[Docket No. FAA-2004-19969; Directorate Identifier 2004-SW-43-AD; Amendment 39-13923; AD 2004-26-11]

Airworthiness Directives; Bell Helicopter Textron Canada Model 222, 222B, 222U, 230, and 430 Helicopters

ACTION: Final rule; request for comments.

Figure 1. Blade inspection area

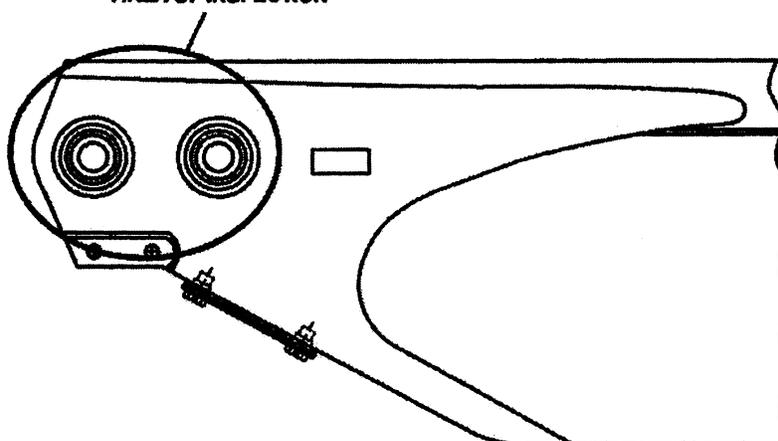
- (a) Within 3 hours time-in-service (TIS) and at intervals not to exceed 3 hours TIS, clean and visually check both sides of each blade for a crack in the paint in the areas shown in Figure 1 of this AD. An owner/operator (pilot), holding at least a private

(b) If a crack is found in the paint while complying with paragraph (a) of this AD, before further flight, inspect the blade by removing the blade and by abrading the area and following the other requirements in paragraph (c) of this AD.

wiping down both surfaces of each blade in the inspection area depicted in Figure 1 of this AD using aliphatic naphtha (C-305) or detergent (C-318) or equivalents. Using a 10X or higher power magnifying glass, visually inspect both sides of the blade in the areas depicted in Figure 1 of this AD.

(1) If even a crack is found in the paint, before further flight, remove the blade.

(2) Remove the paint to the bare metal in the area of the suspected crack by using Plastic Metal Blasting (PMB) or a nylon web abrasive pad. Abrade the blade surface in a span-wise direction only.

(3) Using a 10X or higher power magnifying glass, inspect the blade for a crack.

(i) If a crack is found, before further flight, replace the blade with an airworthy blade.

(ii) If no crack is found in the blade surface, refinish the blade by applying one coat of MIL-P-23377 or MIL-P-85582 Epoxy Polyamide Primer so that the primer overlaps

the existing coats just beyond the abraded area. Let the area dry for 30 minutes to 1 hour. Then, apply one sealer coat of Polyurethane MILC85285 TYI CL2, color Number 27925 (semi-gloss white) per Fed. Std. 595. Reinstall the blade.
